HISTORIC AND DESIGN REVIEW COMMISSION

November 07, 2018

HDRC CASE NO: 2018-533
COMMON NAME: 355 TRAIL
LEGAL DESCRIPTION: NCB 6078 BLK 2 LOTS 9 THRU 14 & 17 THRU 20
ZONING: MF-33, RIO-1
CITY COUNCIL DIST.: 1
DISTRICT: River Road Historic District
APPLICANT: Katie Bingham, AIA/Mark Odom Studio
OWNER: Robert Price
TYPE OF WORK: Construction of twenty-three, residential units
APPLICATION RECEIVED: October 12, 2018
60-DAY REVIEW: December 11, 2018
REQUEST:

The applicant is requesting conceptual approval to construct twenty-three condominium units on the vacant lot located at 355 Trail. The property features lots that are located within the River Improvement Overlay only, as well as those that are located within both the River Improvement Overlay and the River Road Historic District. The applicant has proposed for the condominium units to feature three stories in height. Access to the site will be provided from Trail Street and Huisache Street.

03.1a_Proposed - Site Plan (zoomed in)

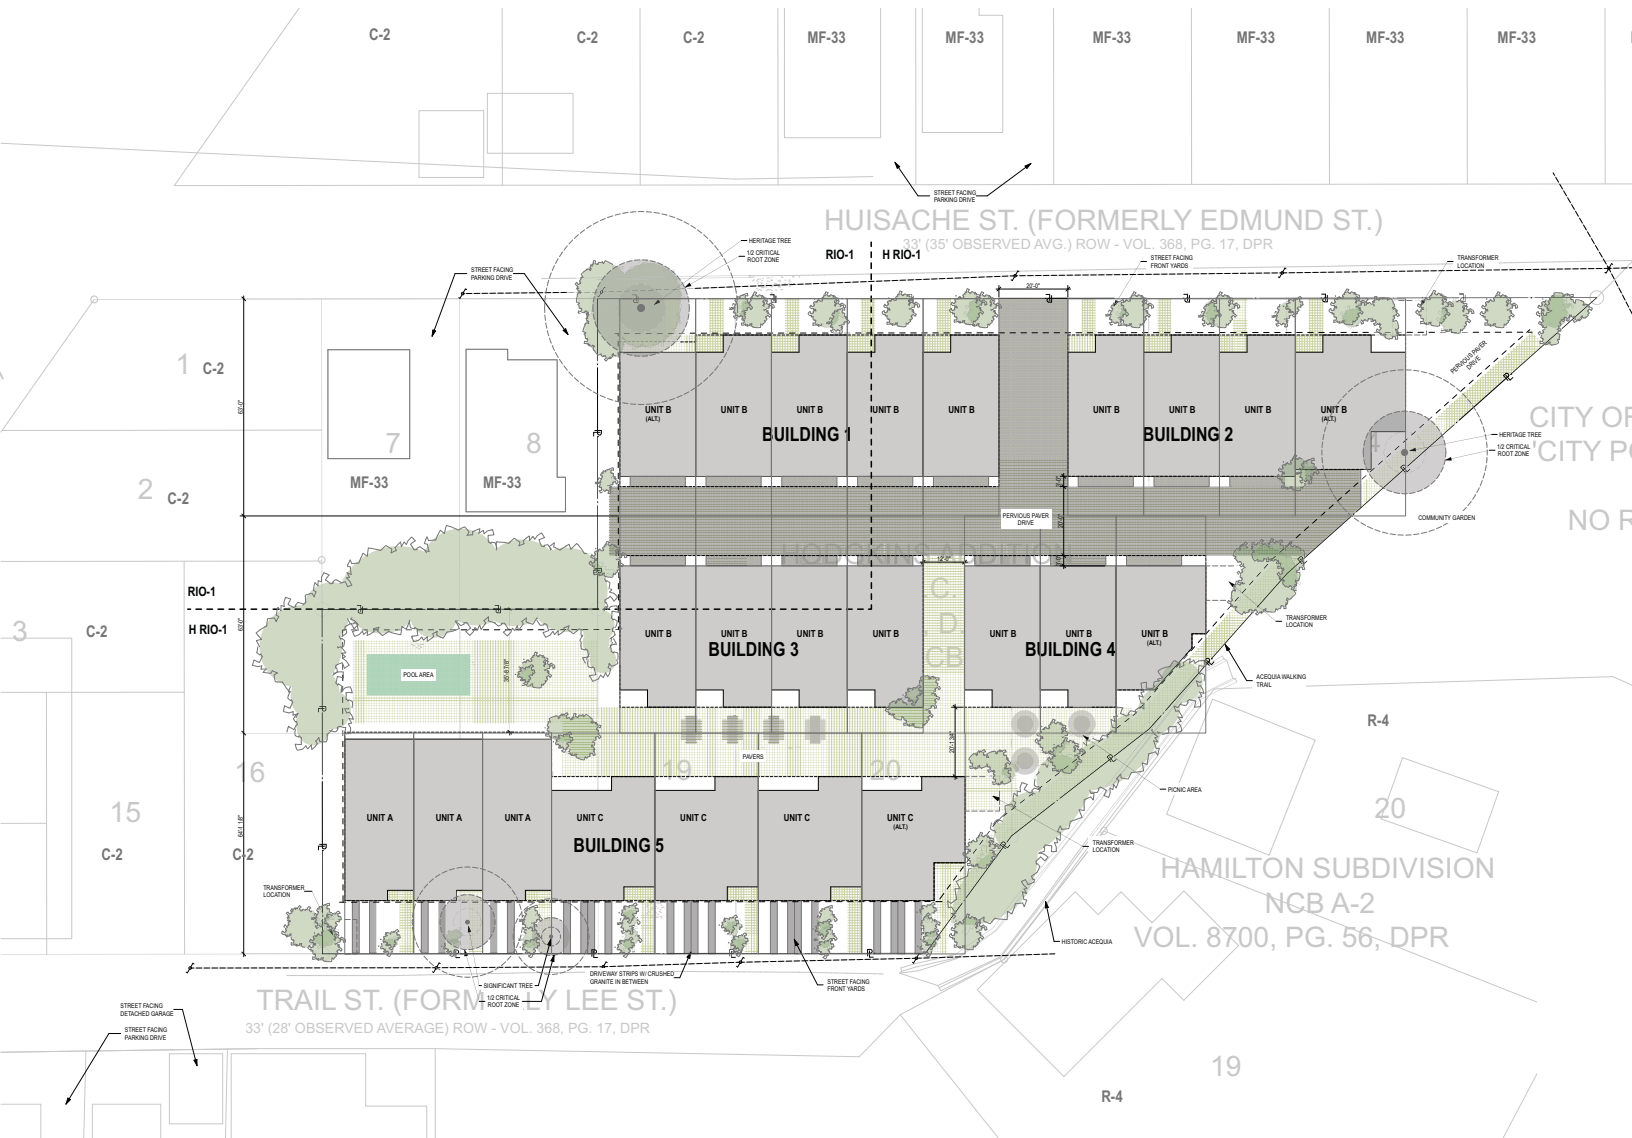
- r. **AUTOMOBILE ACCESS** – The applicant has proposed for a common, central drive to provide automobile access from Huisache to the interior of the site. Generally, staff finds this location to be appropriate; however, staff finds that additional automobile access should be added to the eastern side of the site to accommodate the circulation of automobiles from Trail, north to Huisache.

- s. **LANDSCAPING** – The applicant has provided a site plan noting the locations of proposed landscaping elements. While conceptual in nature, staff finds that additional incorporation of pervious paving materials should be studied.

- t. **TREE PRESERVATION** – The applicant has proposed to remove many of the existing trees on site. Staff finds that the applicant should attempt to preserve the existing, heritage caliber trees. A tree preservation plan should be included with landscaping documents.

Inserting an additional drive through the project would add a large amount of impervious cover and in turn, sacrifice the added green space and vegetation opportunities which we believe negatively impacts the site and the natural environment surrounding it. While the street facing garages along Trail are not ideal, we do believe the benefits outweigh the addition of a secondary internal drive and/or a longer internal driveway from Huisache. Through successful design elements, these garages can easily blend into the townhome facades and be overshadowed by vegetated and well landscaped front yards.
